**US Army Corps of Engineers  
Omaha District  
API 653 Out-of-Service  
Inspection Report**

**Andrews Air Force Base, Morningside, Maryland  
Facility 3473  
Tank 73**

**US Army Corps of Engineers Center of Expertise for Petroleum, Oils and Lubricants  
USACE POL-MCX**

**22 February 2017**

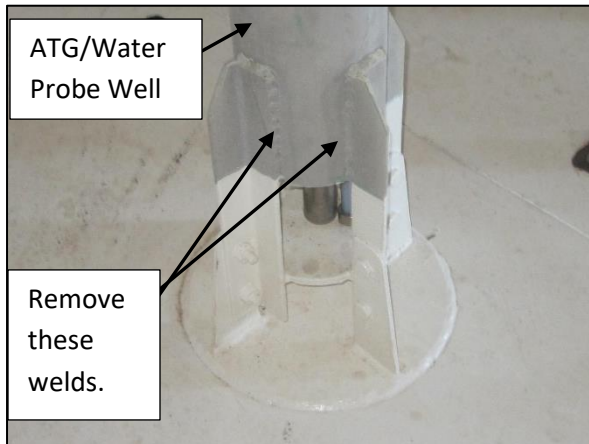
**OBSERVATION:** The 6-inch combination ATG and Vito Water Probe well is bolted to the tank bottom, as well as attached to the tank roof. In addition, the internal ladder is attached to the tank roof manhole neck as well as bolted to its bottom end guides, which are welded to the tank bottom.

**REFERENCE:** API 650 paragraph 5.10.4.7.d) requires columns to be free to move vertically relative to the tank bottom. Guidance for the design of new storage tanks provided in DoD Standard Design AW 78-24-27 allows stilling wells and ladders to be free to move vertically.

**RECOMMENDATION:** Loosen the U-bolts attaching the internal ladder to the roof manhole neck, and double nut the U-bolts to the manhole neck. If the well is not demolished, remove the welds attaching the combination ATG and Vito Water Probe well to the bottom guides.

**d. Remove Insect Screens**

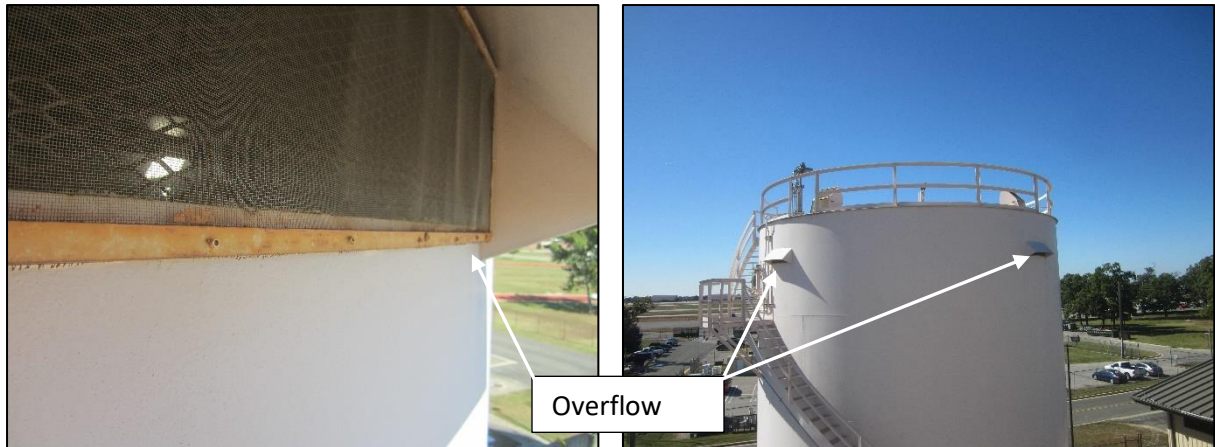
**OBSERVATION:** The four (4) shell overflows are covered with insect screen. Insect screen significantly reduces the ventilation capacity and is subject to clogging. However, as discussed in Section C.4 of this report, only the overflow opposite the stairway and tank nozzles is necessary.

**REFERENCE:** API 650 paragraph H-5.2.2 requires vent screens with 1/2-inch openings.

**RECOMMENDATION:** Remove the insect screen from the shell overflow opposite the stairway and product nozzles.

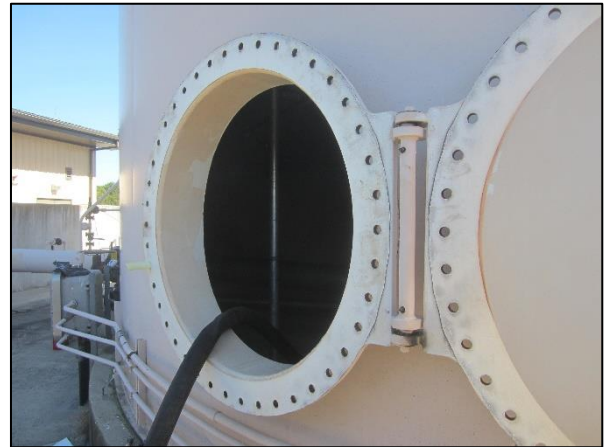
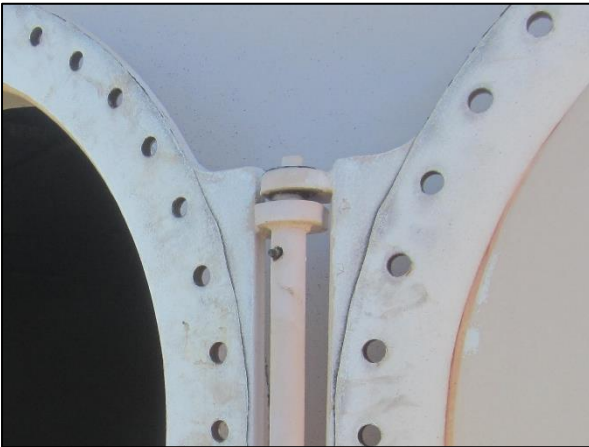
**OBSERVATION:** A conduit junction box with a threaded cover is missing its gasket/ O-ring.

**REFERENCE:** NFPA 70 paragraph 500.5(B)(2)(1) and guidance for new construction provided in UFC 3-460-01 Paragraph 2-12.1.1 considers all outdoor locations within 5 feet of fuel storage tanks to be Class 1 Division 2. NFPA 70 paragraph 500.7 requires electrical equipment that is not intrinsically safe and used in Class I Division 2 locations to be explosion proof.

**RECOMMENDATION:** Provide a gasket/O-ring for the electrical junction box shown to ensure the electrical junction box is explosion proof.

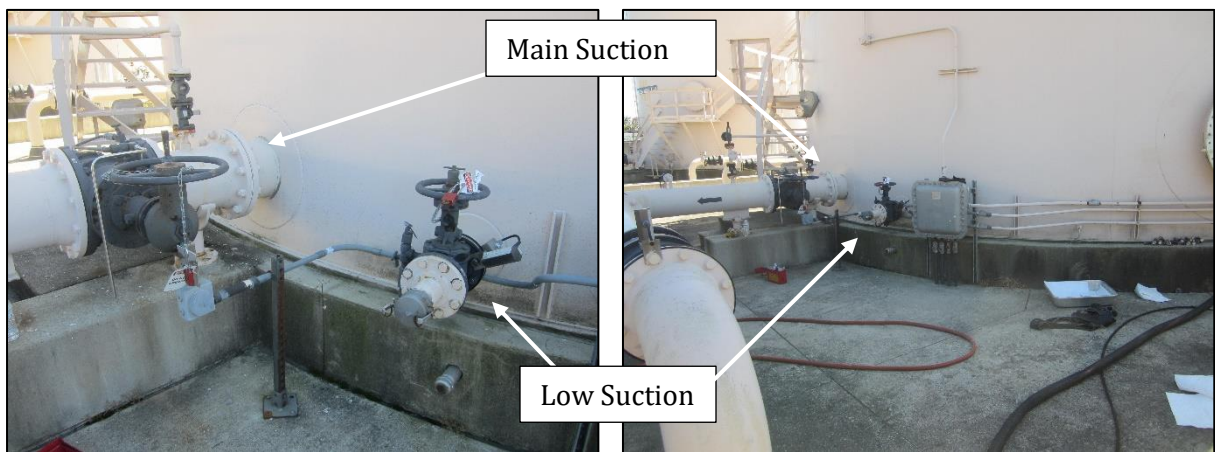
**OBSERVATION:** The low suction nozzle is not piped to allow using the issue pumps to drain the tank in preparation for tank cleaning and entry. In theory, the location of the internal low suction piping could potentially reduce the self-cleaning action of the cone down bottom.

**REFERENCE:** Guidance for the design of new storage tanks provided in UFC 3-460-01 Table 8-1, Item v and DoD Standard Design AW 78-24-27 include hard piping the low suction to the main suction.

**RECOMMENDATION:** If the time and cost of removing the last few hundred barrels of fuel from the tank in preparation for cleaning and or maintenance is an issue, consider providing piping and valves to connect the low suction to the main suction.

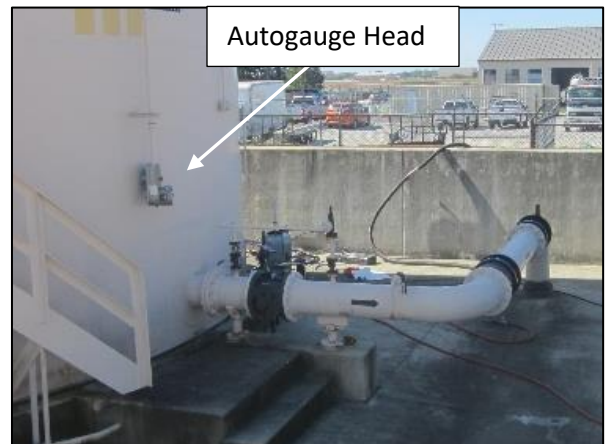
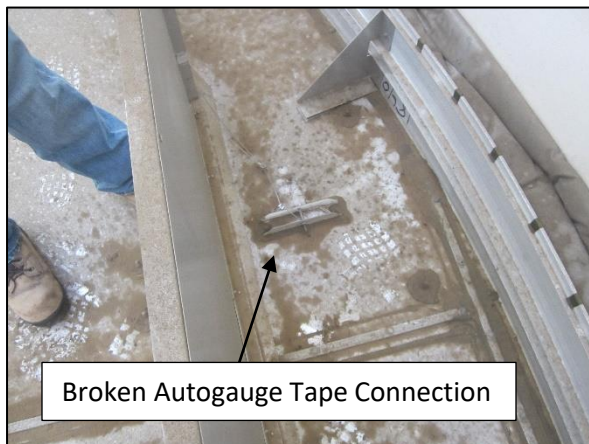
**OBSERVATION:** The internal issue piping is not resting on its pipe support. The internal pipe supports are adjustable. However, the tank bottom may be expected to flex downward and piping to flex upward, due to the weight of the fuel and buoyancy of the pipe, when the tank is filled, thus widening the gap between the piping and the supports.

**REFERENCE:** DoD Standard Design AW 78-24-27 includes internal bolted pipe supports with slotted holes for adjusting the height of the support.

**RECOMMENDATION:** If supporting the internal piping when the tank is empty is a concern continue to readjust the internal pipe supports whenever the tank is taken out of service for cleaning.

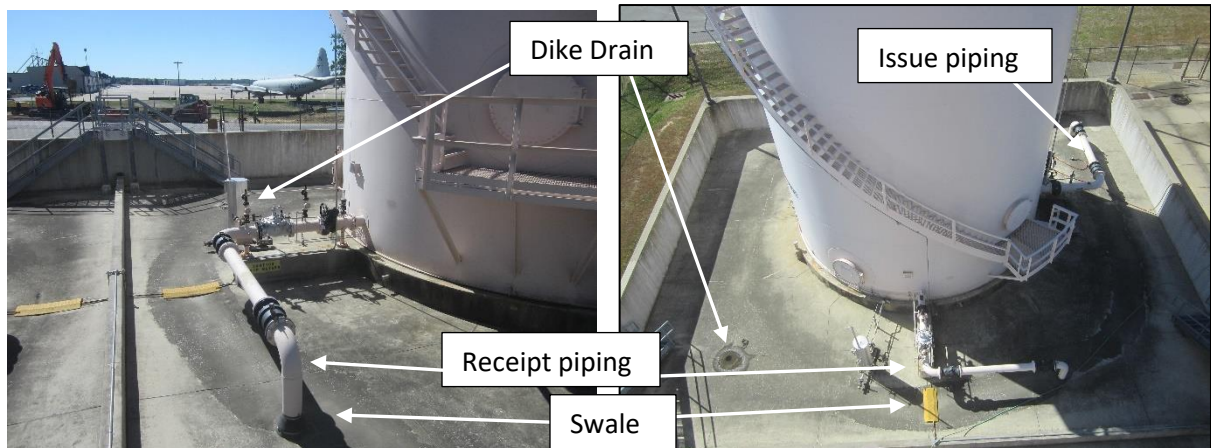
**OBSERVATION:** A concrete dike and basin provide secondary containment, which is shared with the sister tank (Facility 3474). The distance of the swale from the tank varies from 6 to 10 feet from the tank. The receipt piping runs over the swale.

**REFERENCE:** NFPA 30 paragraph 22.11.2.1 requires secondary containment to be sloped away from the tank for 50 feet or to the dike wall, whichever is less. NFPA 30 paragraph 22.12.2.1 requires the dike basin to also be sloped away from the piping for a distance of 50 feet.

**RECOMMENDATION:** If future projects include major modifications to the site, consider modifying the secondary containment to slope to the drain and away from the tank all the way to the dike wall and away from the piping.

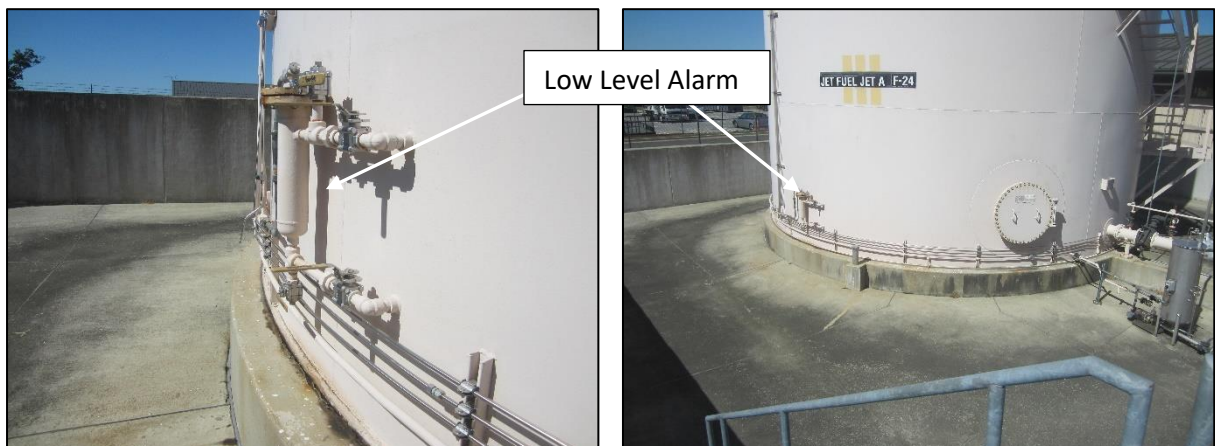
**OBSERVATION:** The only shell mounted low level alarm is located below the low leg level of the floating pan and has threaded connections.

**REFERENCE:** Guidance for new construction provided in DoD Standard Design AW 78-24-27 includes low and low-low level alarm chambers above the low leg level of the floating pan. Guidance for new construction provided in UFC 3-460-01 paragraph 9-8.e) prohibits installing threaded piping on new fuel piping.

**RECOMMENDATION:** If ensuring the operating level of the fuel is high enough to realize the benefit of a full contact floating pan is desired, demolish the existing low level alarm chamber, nozzles, piping, and sensors. Provide new shell mounted low and low-low level alarms at the proper levels.
